UNITED STATES PATENT AND TRADEMARK OFFICE

APPLICATION NO.	FILING DATE	FIRST NAMED INVENTOR	ATTORNEY DOCKET NO.	CONFIRMATION NO.
09/775,370	02/01/2001	Tammy Zheng	VLSI.225DIV1	8675

Office Action Summary	Application No.		Applicant(s)	
	09/775,370		ZHENG ET AL.	
	Examiner		Art Unit	
	Leonardo Andújar		2826

DETAILED ACTION

FIG. 3

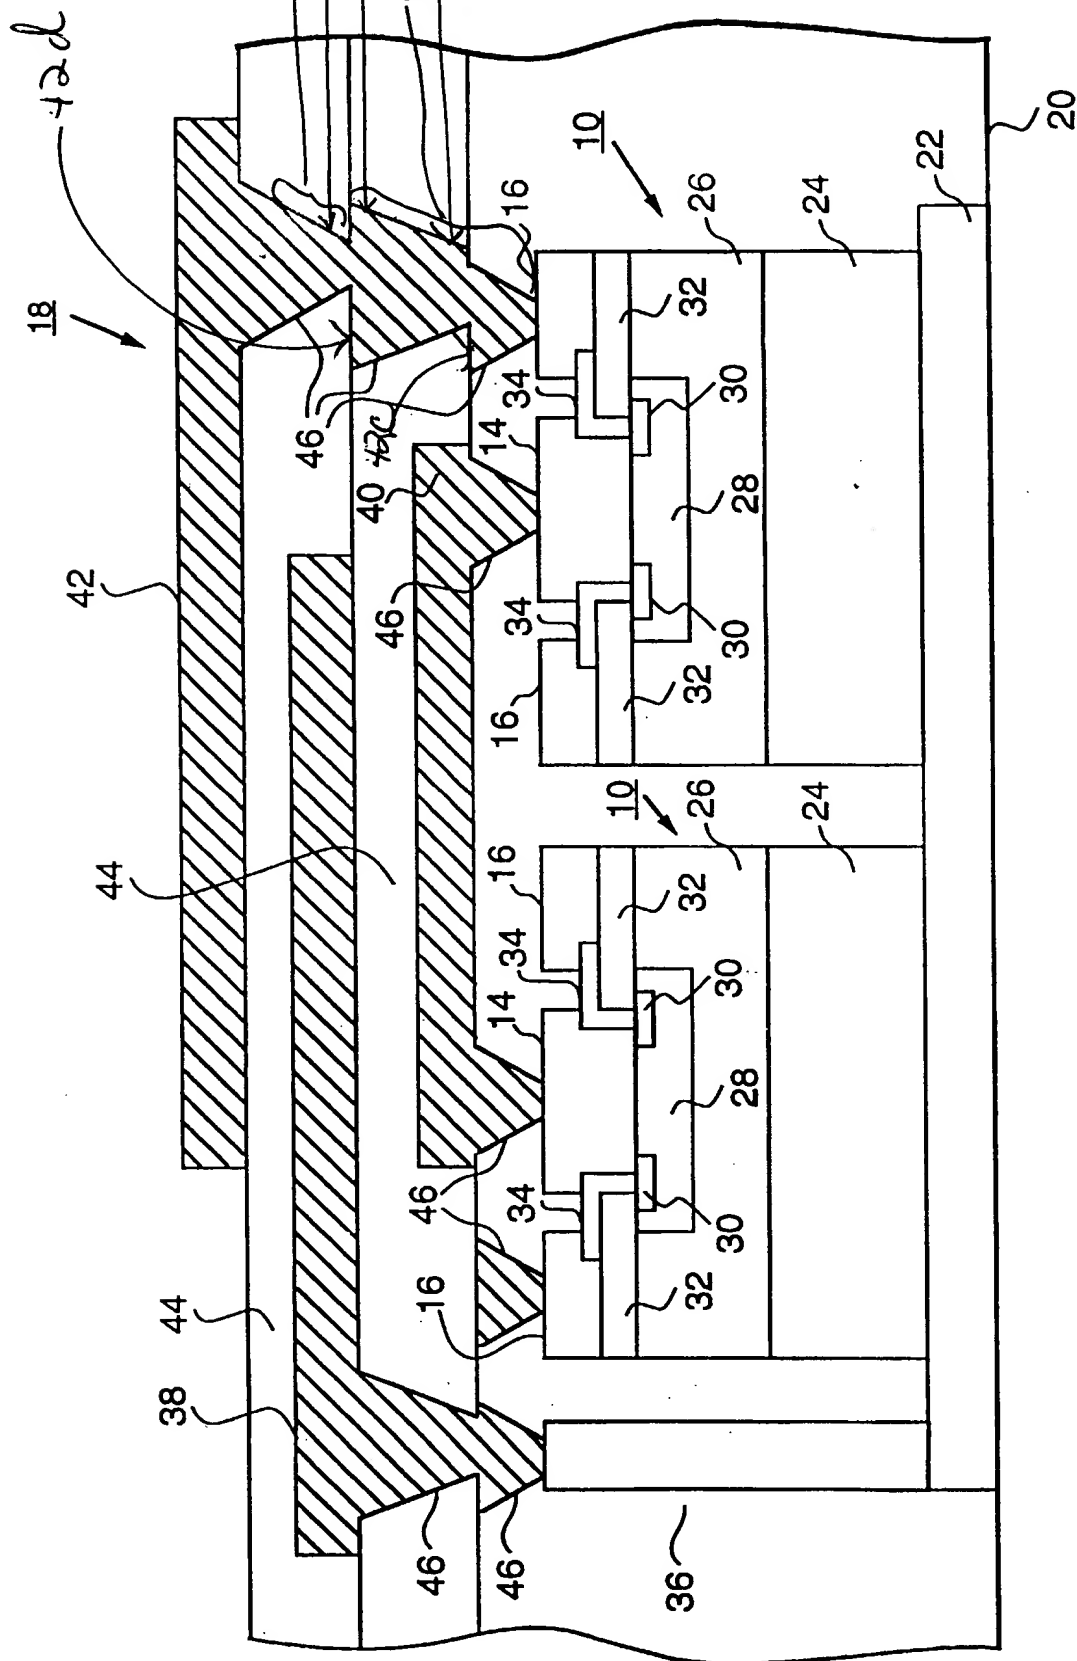
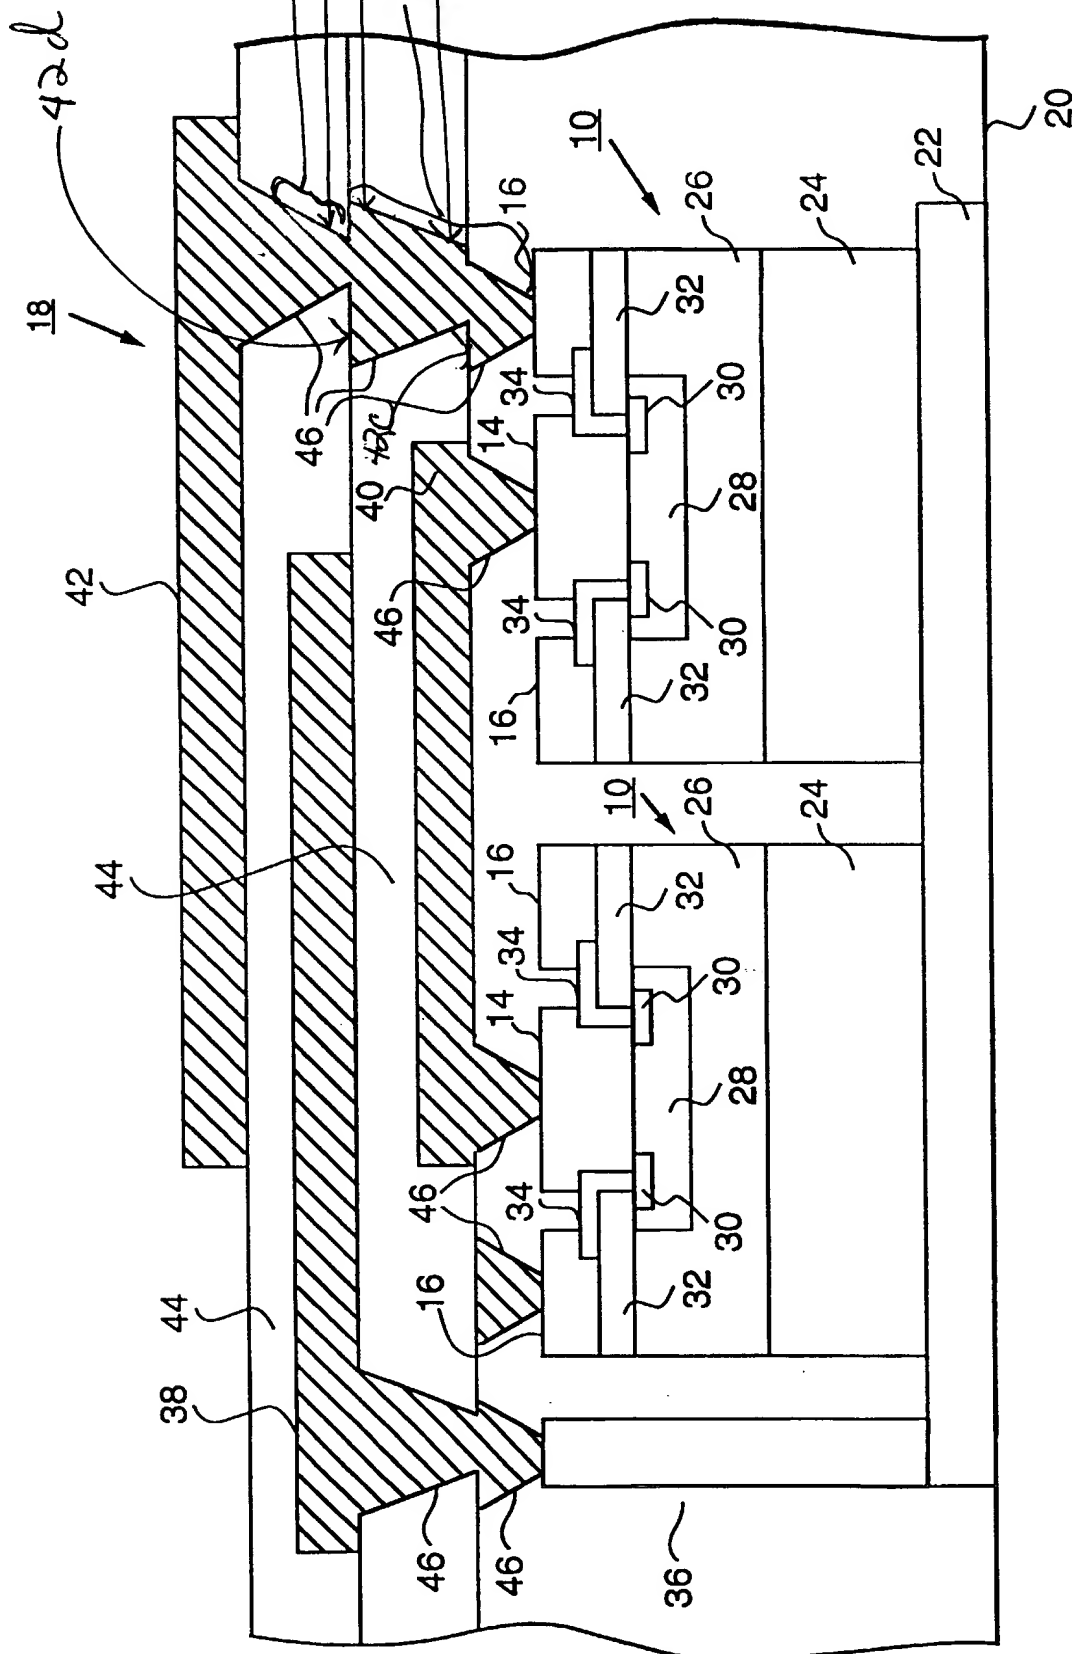
15. Regarding claim 27, Korman (see attachment) shows a semiconductor device comprising:

- A first metal portion 16 over a substrate;
- A dielectric layer 44 above the first metal portion;
- A second metal 42a portion above the dielectric layer;
- A single layer plug 42b extending from the first metal portion through the dielectric layer to the second portion.

16. Moreover, the plug has a first upper surface 42c extending laterally beyond the second metal portion and substantially planar to an upper surface of the dielectric layer and a second upper surface 42d that extends above the first upper surface (see attachment). The single layer plug is made of copper (col. 5/ll. 23). However, Korman does not disclose that an aluminum alloy can be used to make the single layer plug. Green discloses the interchangeability between aluminum alloy and copper as metalization materials. Moreover, Green discloses that the metalization materials

18. Regarding claim 33, Korman shows that the dielectric layer 44 is a single layer dielectric.

20. Regarding claim 35, Korman shows that the plug does not exhibit a void.

21. Regarding claim 36, Korman shows that the second upper surface of the single layer plug is substantially planar with a second upper surface of the second dielectric layer 44.

22. Regarding claim 37, Korman shows that the portion of the dielectric layer including the second upper surface has a side wall portion SD2 that is substantially

aligned with a first side wall portion of the second metal layer SD1, and wherein the portion of the plug including the second surface has a side wall SD3 portion that is substantially aligned with the second side wall portion of the second metal layer SD1.
